BRUSHCUTTER ATTACHMENT
CSA850/28 (967026901)

Illustrated Parts List - IPL Update

CSA850/28

ATTACHMENTS

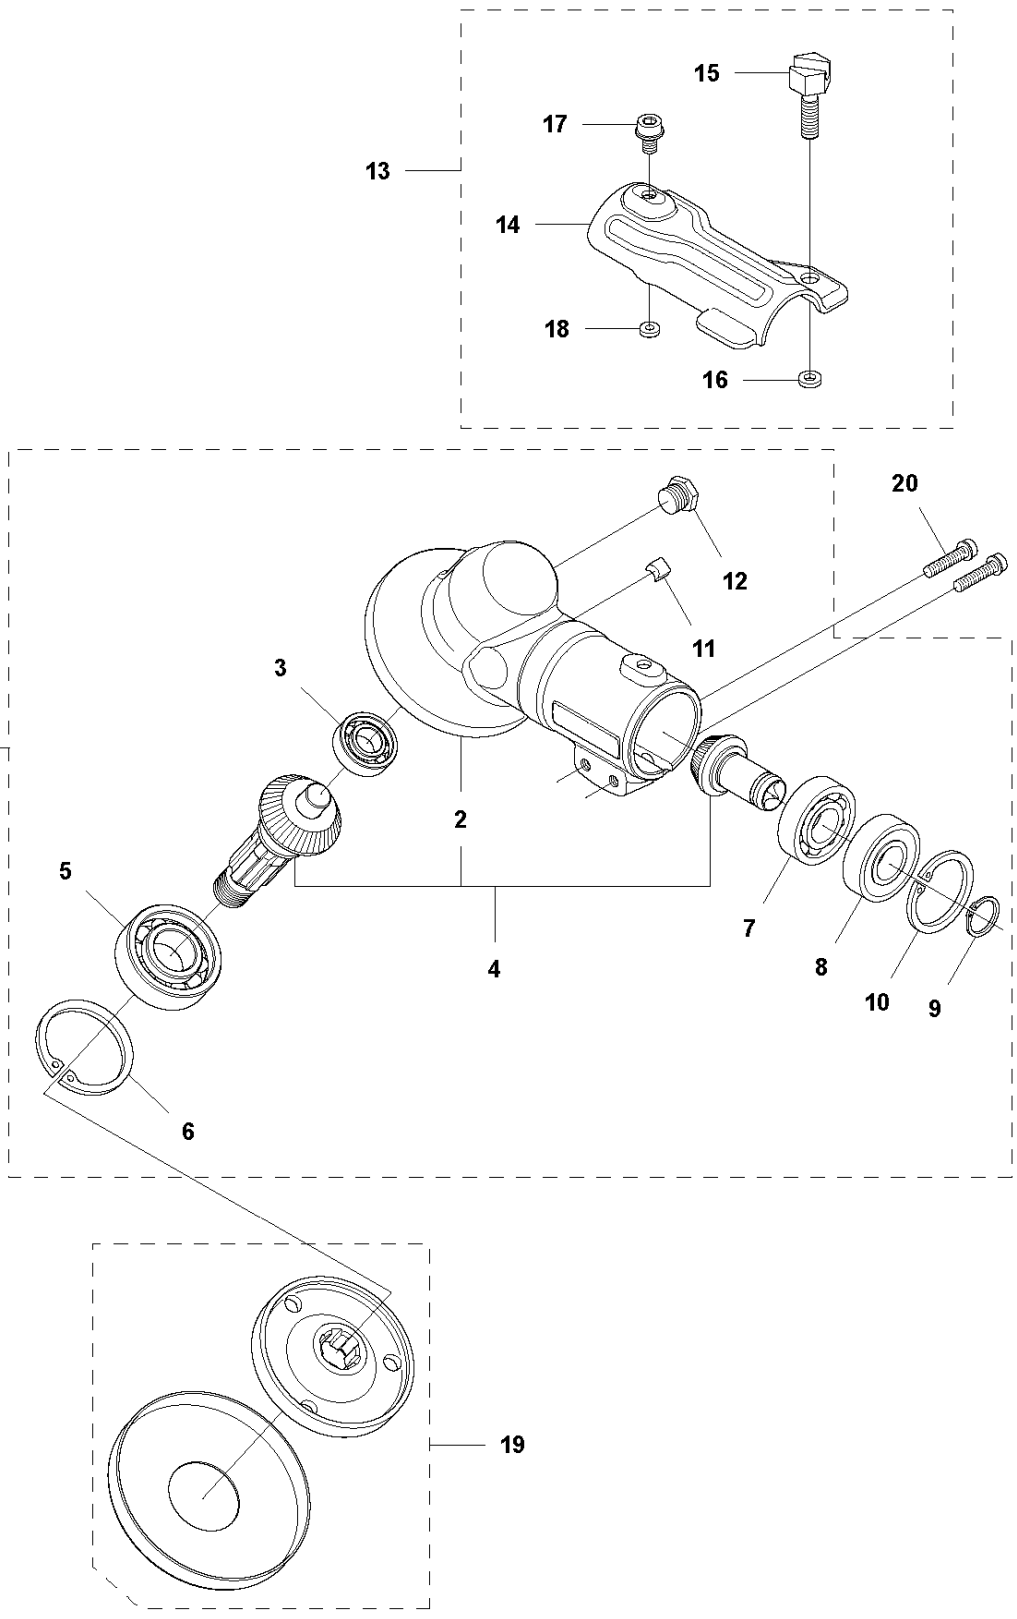
New drive shaft and plastic clip. These components will make it easier to assemble the detachable machine.

The plastic clip can only be used with tube assy 588 15 61-01. The new drive shaft is backward compatible with tube assy 577 71 06-01.

Page title	Ref. no	New part no	Name	Excl. part no.	Remark
Attachments	14	586 89 79-01	Drive shaft	577 60 35-01	
Attachments	25	586 89 77-01	Clip	N/A	Compatible with tube assy 588 15 61-01 only.
